APPLICATION NO.	FILING DATE	FIRST NAMED INVENTOR	ATTORNEY DOCKET NO.	CONFIRMATION NO.
10/573,302	09/07/2006	Gad Alon	L&C UMB 710 US	9566
71385	7590	04/28/2008	EXAMINER	
LARCHER & CHAO LLP P.O. BOX 1666 SKOKIE, IL 60076			ROBINSON, JAMES MARSHALL	
			ART UNIT	PAPER NUMBER
			4148	
			MAIL DATE	DELIVERY MODE
			04/28/2008	PAPER

Office Action Summary	Application No. 10/573,302	Applicant(s) ALON ET AL.	
	Examiner James M. Robinson	Art Unit 4148

DETAILED ACTION

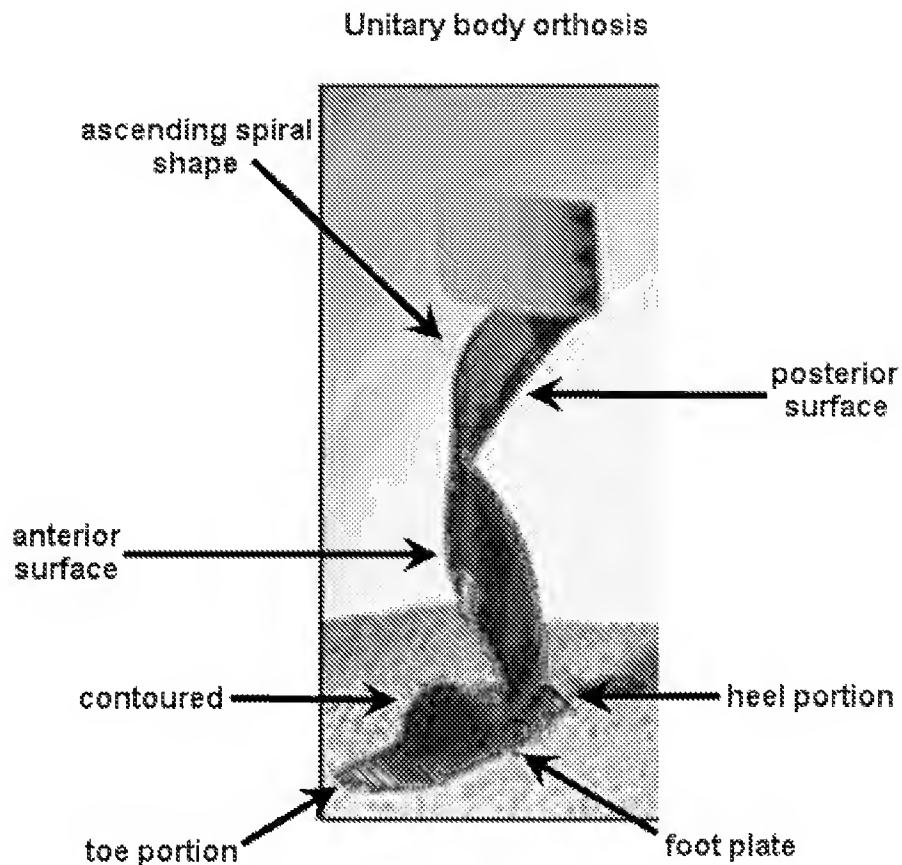
Regarding claim 1, Michael discloses an orthosis comprising a single, unitary body comprising: a generally spiral-shaped lower leg portion that, when the orthosis is worn, covers at least a portion of the anterior surface of the wearer's lower leg and at least a portion of the posterior surface of the wearer's lower leg; and a foot plate portion that, when the orthosis is worn, accepts the wearer's foot, wherein the lower leg portion is configured to spiral upward from the foot plate portion and make contact with an anterior surface of the wearer's lower leg prior to making contact with a posterior surface of the wearer's lower leg as the lower leg portion ascends (see fig. below).

Regarding claim 2, Michael discloses an orthosis wherein the foot plate portion comprises an anterior section; and a posterior section, wherein, when the orthosis is worn, the wearer's toes contact the anterior section and the wearer's heel contacts the posterior section, and wherein the foot plate portion is optionally contoured to complement at least a portion of the plantar surface of the wearer's foot so as to permit the wearer to wear shoes or sandals (see fig. above).

Regarding claim 4, Michael discloses an orthosis wherein the lower leg portion comprises an ascending section that extends from the foot plate section and curves toward the anterior surface of the wearer's lower leg to form a shin section (see fig. above).

Regarding claim 5, Michael discloses an orthosis wherein, from the shin section, the lower leg portion spirals around at a least a portion of a lateral surface of the wearer's lower leg and transitions into a calf section (see fig. above).

Regarding claim 7, Michael discloses an orthosis wherein the angle at which the lower leg portion spirals upward gradually decreases as the lower leg portion nears the calf of the wearer (see fig. above). The degree of the angle of the spiral at the calf is less than the degree of the angle at the shin. This change in the degree of the angle is gradual.

Regarding claim 20 Michael discloses an orthosis wherein the foot plate portion comprises a front edge and a back edge (refer to figure above), wherein the back edge is elevated above the front edge (the contour of the foot plate creates the elevation).

Regarding claim 21 Michael discloses an orthosis wherein the foot plate portion comprises a front edge and a back edge (refer to figure above), wherein the distance between the back edge and ground level is about twice the distance between the front edge and ground level (the contour of the foot plate creates the distance between the back edge and the ground level).

Regarding claim 33, Michael discloses an orthosis wherein the foot plate portion has a substantially flat outer surface (see fig. above).

Regarding claims 15 & 18, Michael discloses an orthosis wherein the foot plate portion and the lower leg portion are disposed at an angle with respect to one another (refer to figure above).

Regarding claim 23, Michael discloses an orthosis wherein the foot plate portion comprises an anterior section and a posterior section (refer to figure above) wherein a difference in elevation exists between the anterior section and the posterior section as a result of the contour of the foot plate.
